**HISTORIC LANDMARK COMMISSION
MAY 20, 2013
NATIONAL REGISTER HISTORIC DISTRICT
NRD-2013-0038
Sixth Street
418 E. 6th Street**

PROPOSAL

Install new doors in existing openings and add a rooftop deck on a contributing building.

**A1.1
 STOREFRONT**

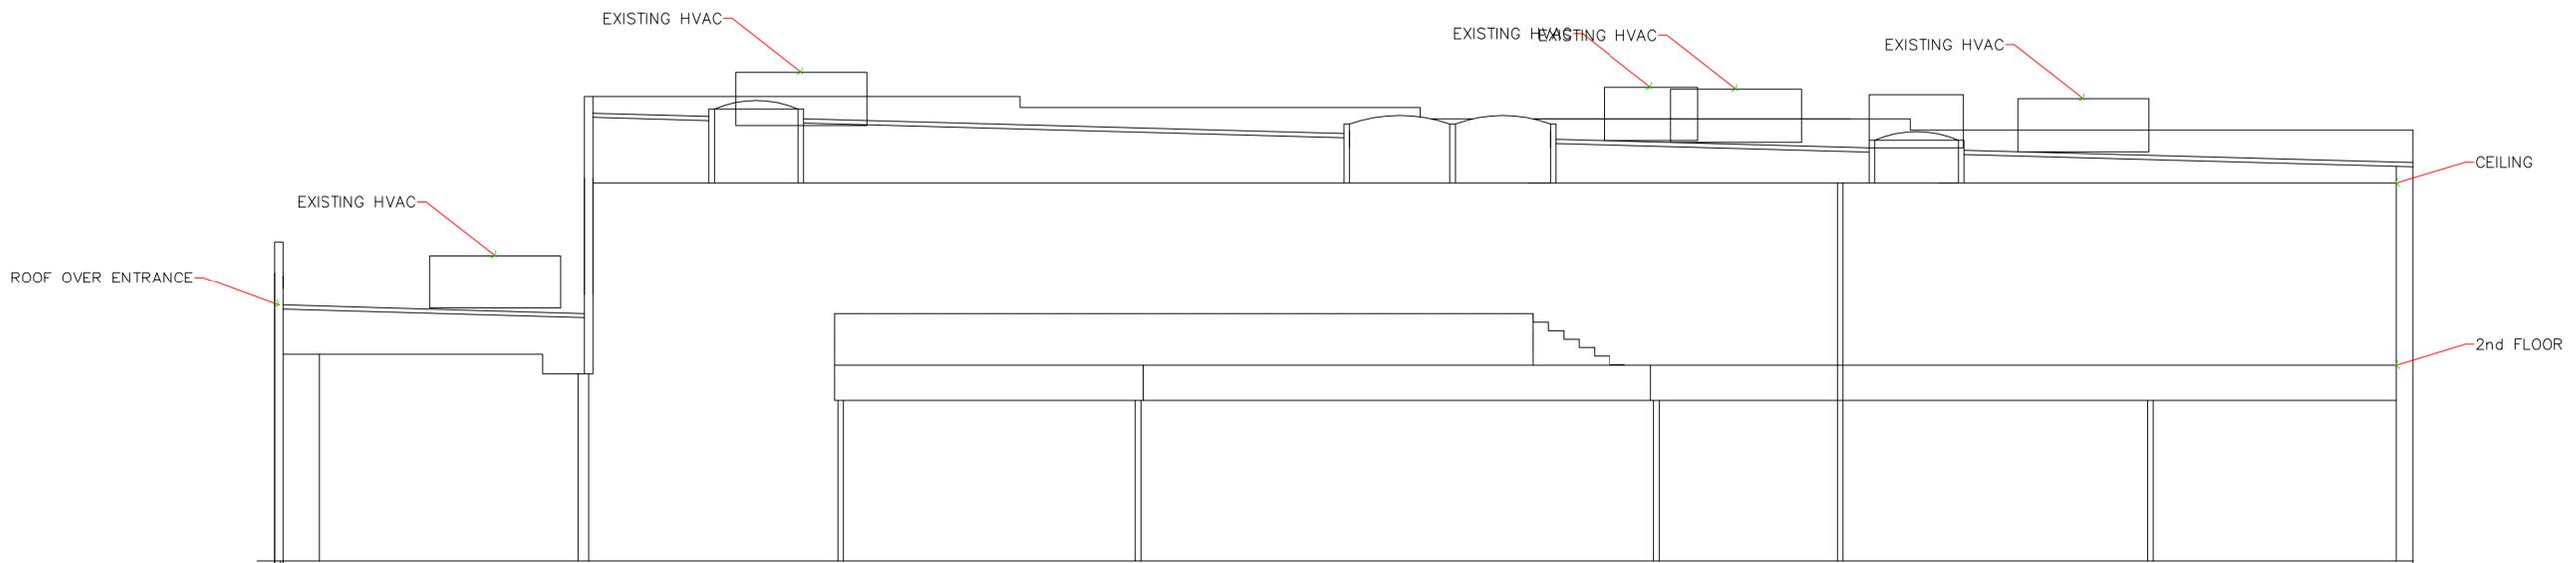
The addition of the horizontal band of windows on the façade of the second story is not compatible with the existing building or the architectural character of the National Register District. A window configuration more similar to those found on historic buildings would be more compatible.

The new double entry doors and trifold doors do not meet the guidelines, which call for replicating a more historic design and configuration when possible. Additionally using opaque material to fill in areas of the openings not filled in with the new doors does not meet the guidelines.

Release the permit; however, highly recommend that the applicant reconsider the rooftop deck and either eliminate it from the design, or propose a design that is less visible from the street. Additionally, recommend that the applicant design more historically appropriate storefronts, entry doors, and second story windows.

A1.2 Section

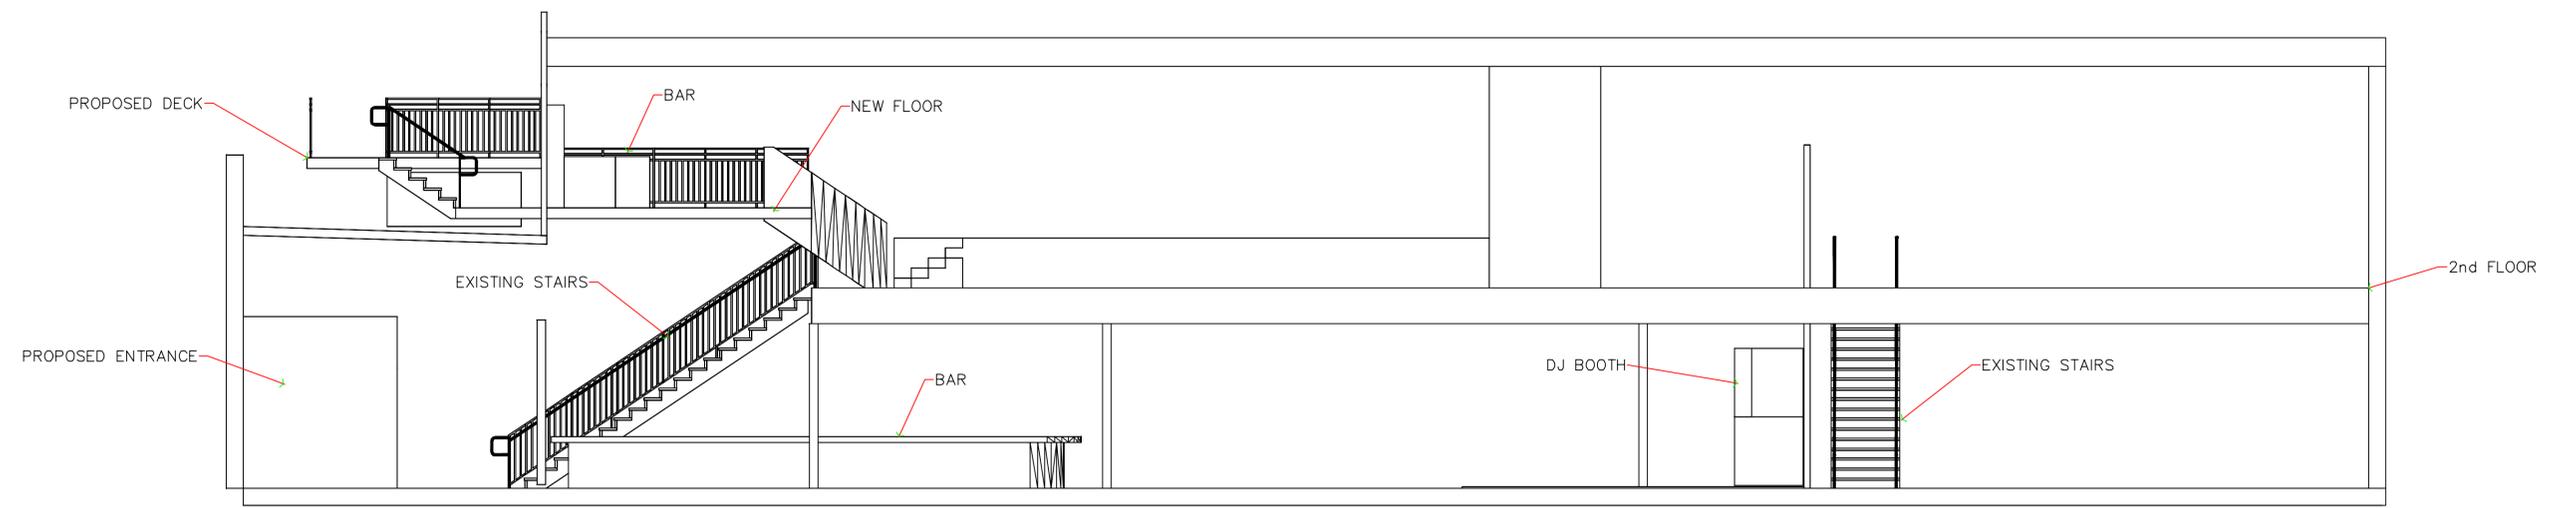
The proposed rooftop deck - being suspended above the existing roof and set only 5'-0" from the parapet - does not meet the guidelines. The deck should be set further back from the façade and/or lowered so it is not visible from the street.
